PLANNING COMMISSION

- a. Northwood Estates Subdivision, Phase 4 Extension Request (MISC 20-01).

- a. A request from Caruso Produce for a Site and Design Review to construct a 90,000-square-foot produce distribution facility on a 9.59-acre lot located on the north side of the future extension of SE 4th Ave, just east of S Sequoia Parkway. (DR 19-02).

Staff Report File #: DR 19-02 – Caruso Produce

A
G1.0
SITE PLAN
1" = 40'-0"

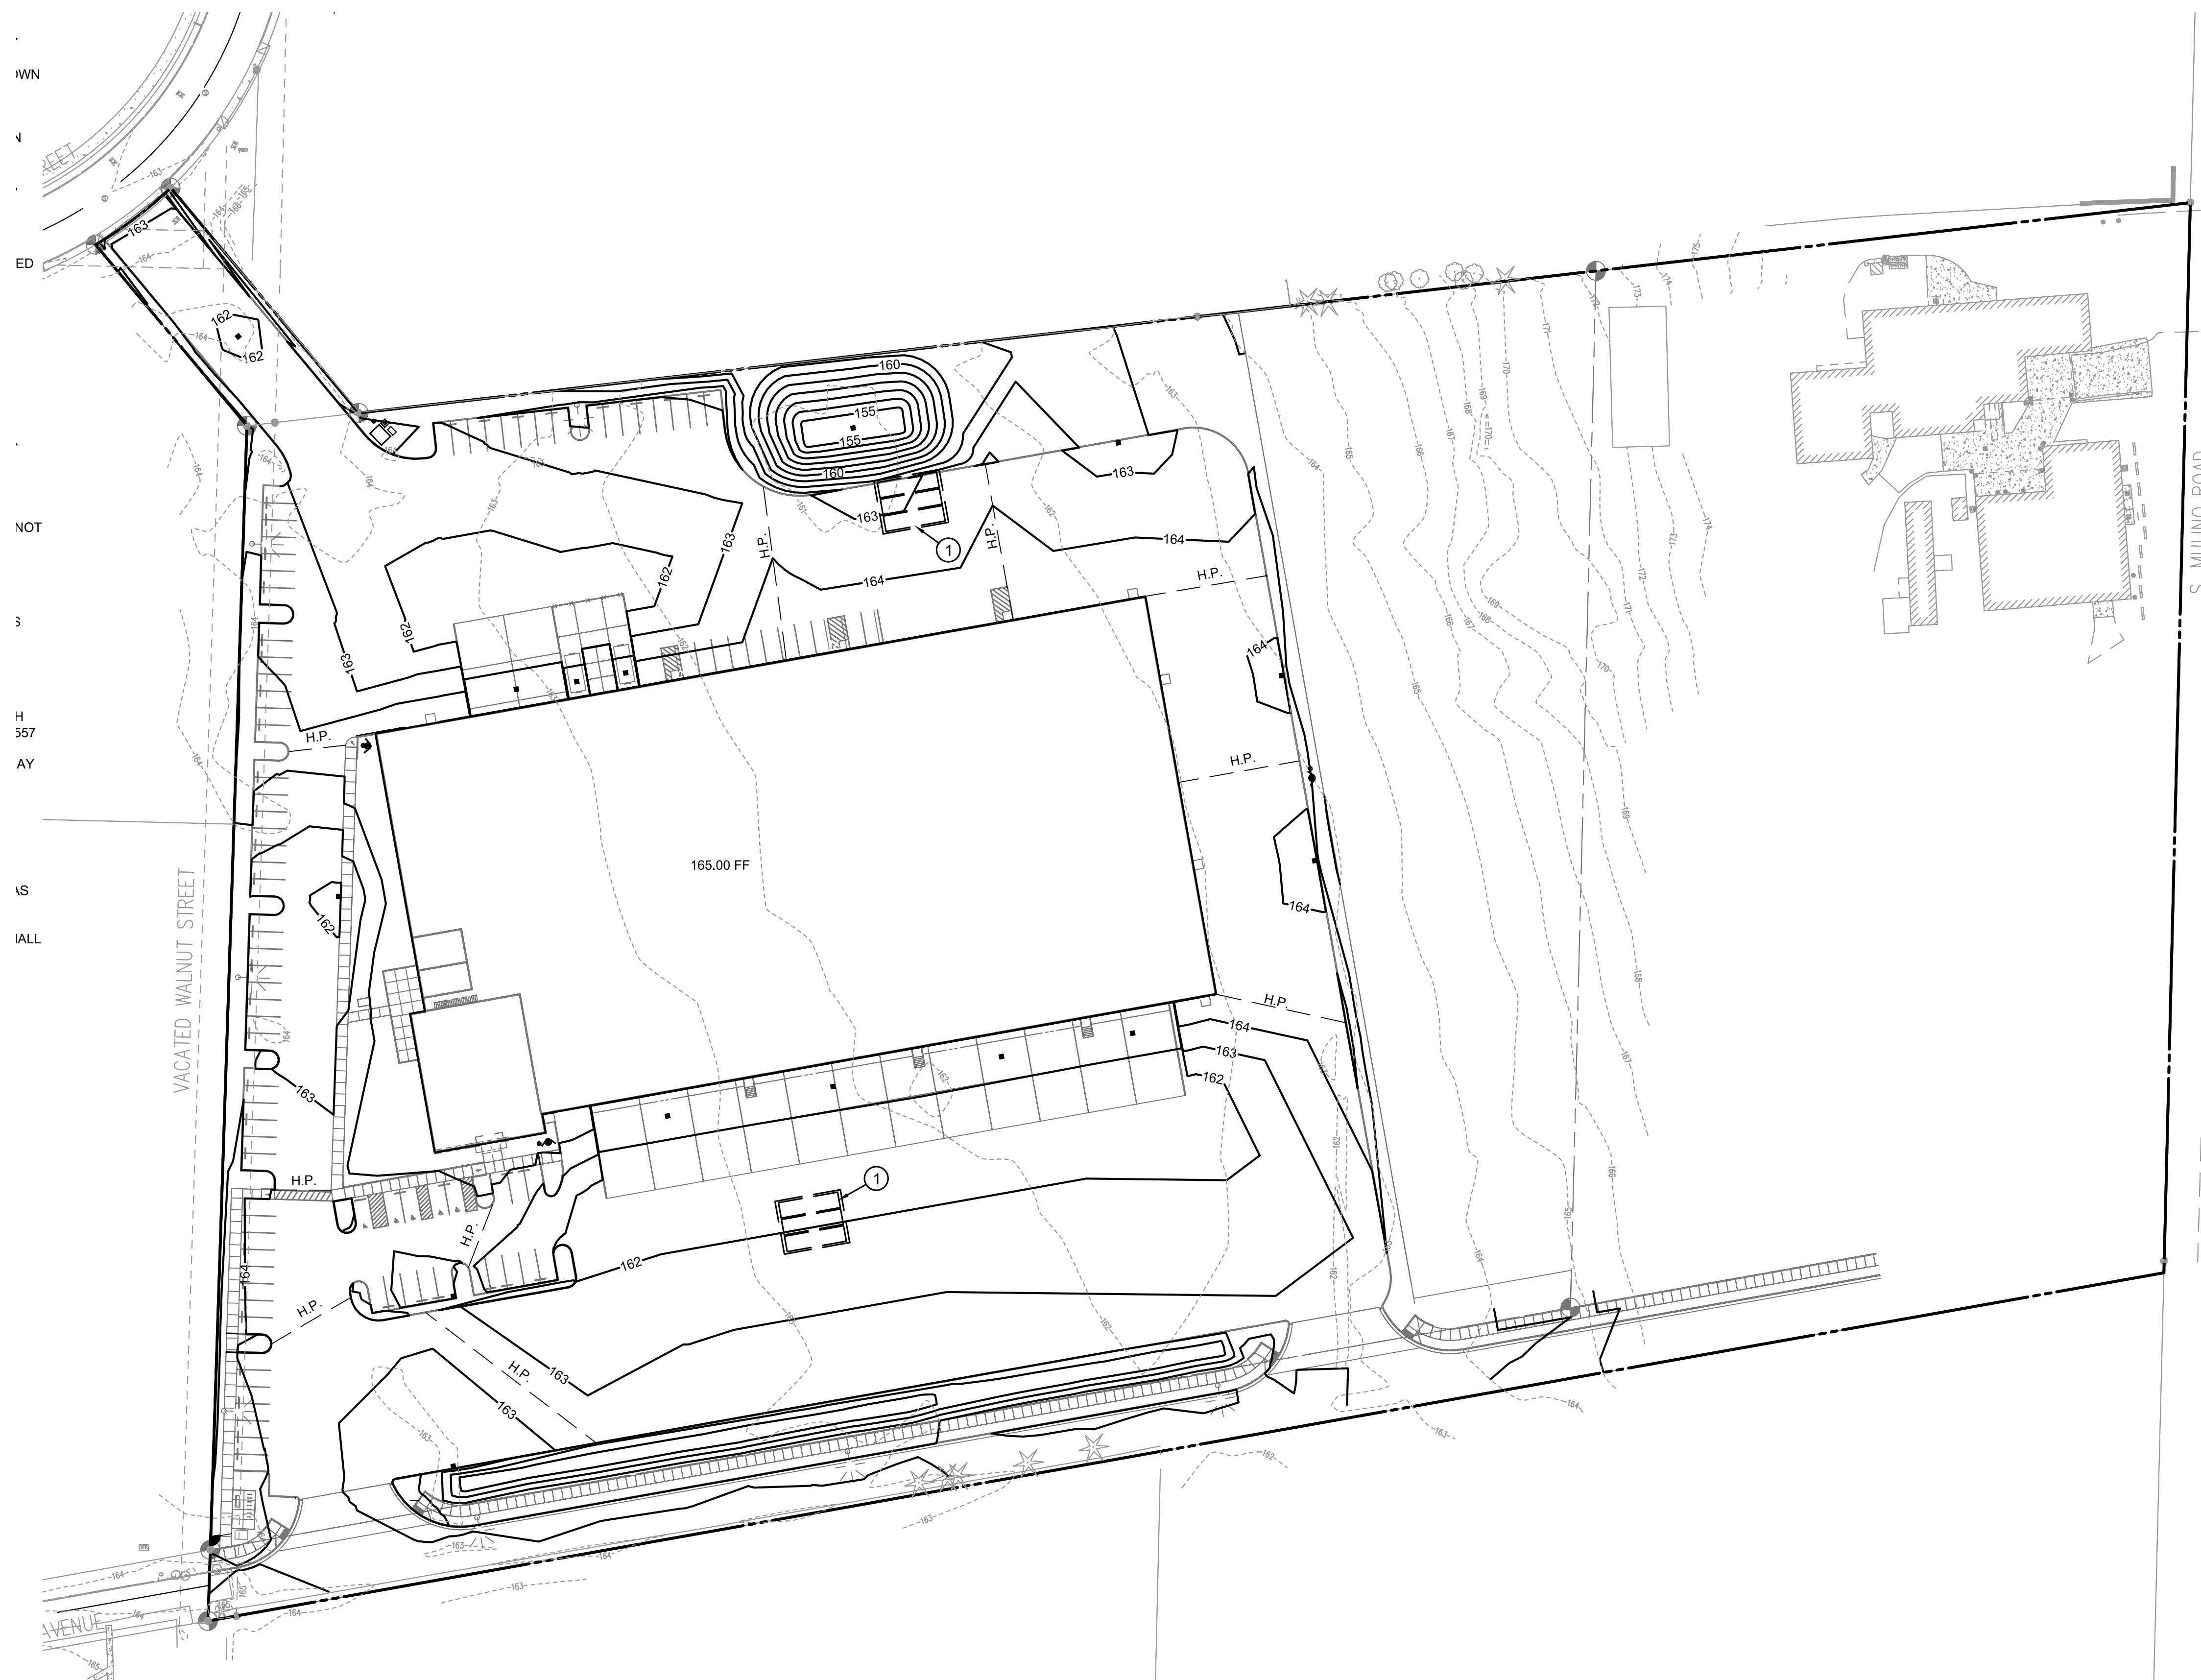
acceptable score unless Planning Staff determines that certain provisions do not apply. The proposed project meets the minimum scores by category except the “Transportation/Circulation” category, which addresses pedestrian pathways and connections. The applicant requests an exception to the requirements for a second pedestrian access and a raised concrete pedestrian connection across the drive aisle. City Staff concurs that site constraints make a second pedestrian connection between the street and building infeasible (due to circulation of truck traffic to and from SE 4th Avenue and the site’s narrow connection to S Walnut. Although it is assumed the employee parking area’s drive aisle would generally not be used for truck circulation, Staff also concurs that an enhanced pedestrian connection across this drive aisle is not compatible with any amount of heavy truck circulation. Therefore, a striped pedestrian path across the western drive aisle is appropriate.

10. Consistent with Subsection 16.10.100, *Bicycle Parking*, of the Municipal Code, the proposed bicycle parking shall be moved to within 50 feet of the main entrance of the building. Prior to site plan approval, the project applicant shall submit a final site plan demonstrating that the location and design of proposed bicycle parking conforms to the aforementioned code section.

LANDSCAPE PLAN

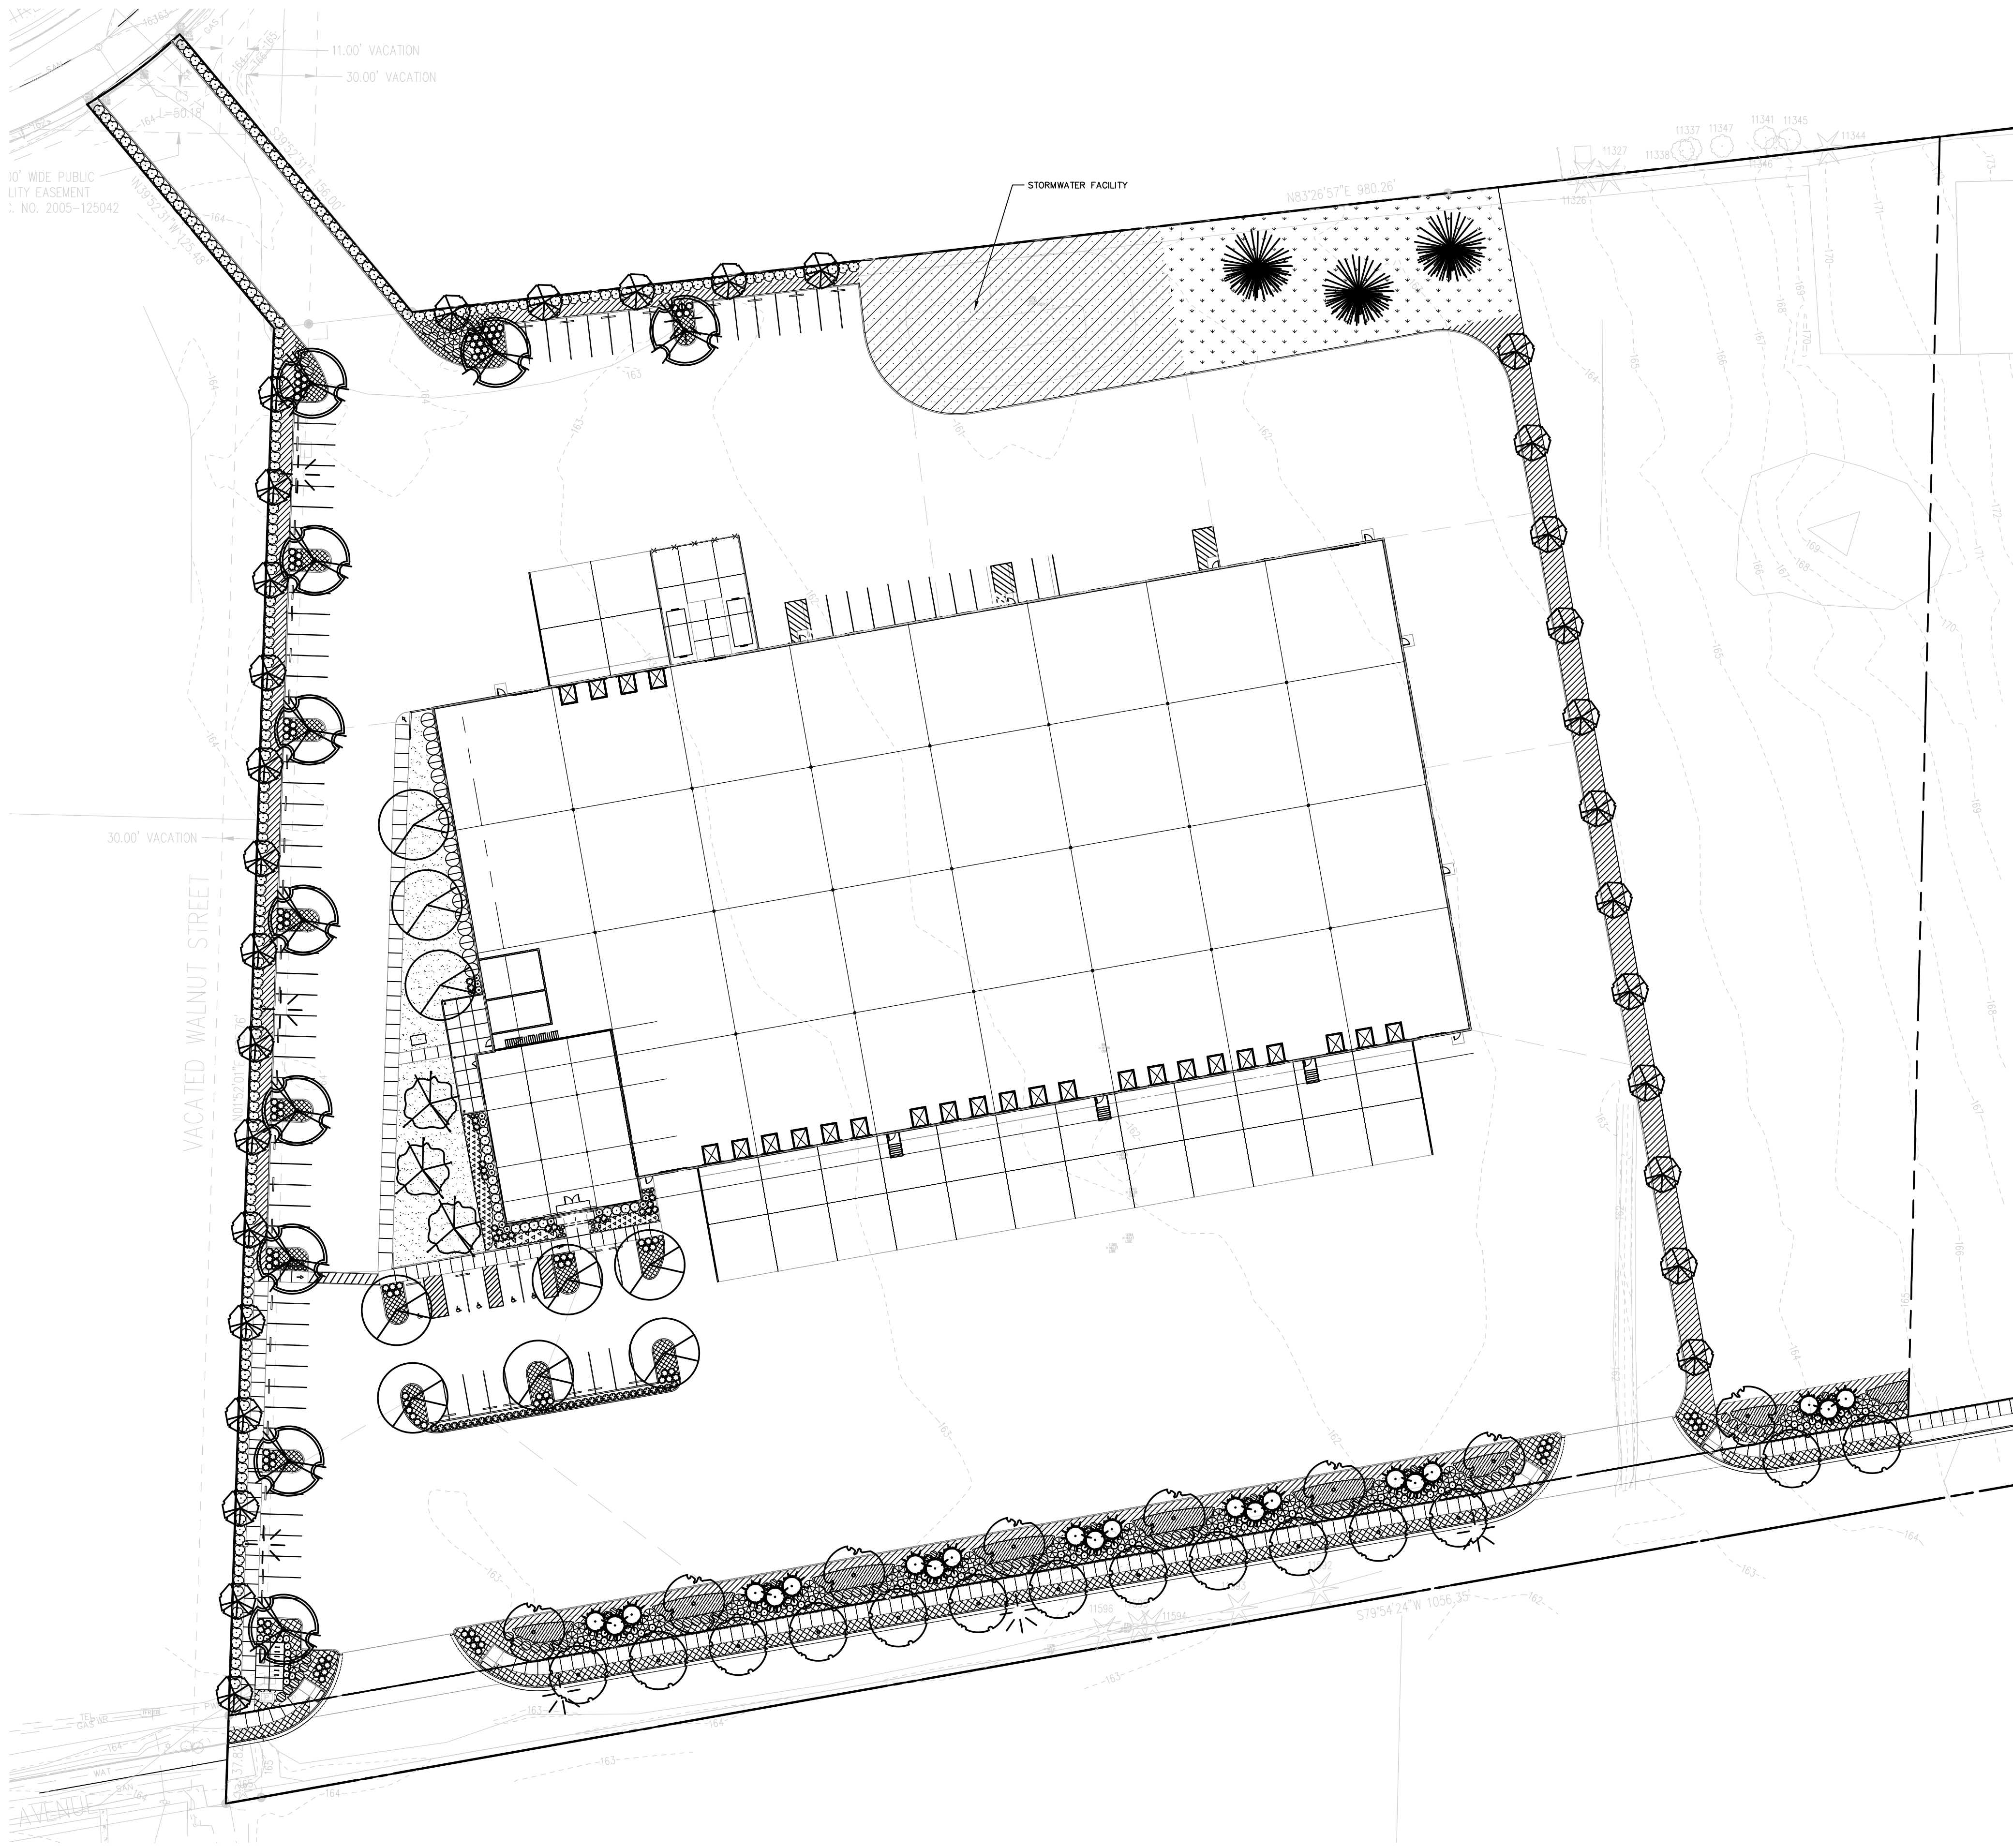
- **Landscaping.** The submitted materials demonstrate general compliance with landscaping standards. For example, the project provides landscape islands between each grouping of eight contiguous parking spaces. However, the proposed site plan identifies a large expanse of land at the eastern edge of the project site that would remain vacant. Subsection 16.49.130 requires areas not planned for development or landscaping to be vegetated with plant materials that will prevent erosion. Section V of this Staff Report includes a condition requiring vegetation of this area. As identified in the code, landscaping and

13. The project applicant shall plant vegetation on the portion of the subject property that is proposed to be vacant (on the eastern edge of the project site) with plant materials that will prevent erosion of exposed soils. Prior to site plan approval, the project applicant shall provide the City with an updated landscape plan showing these improvements.
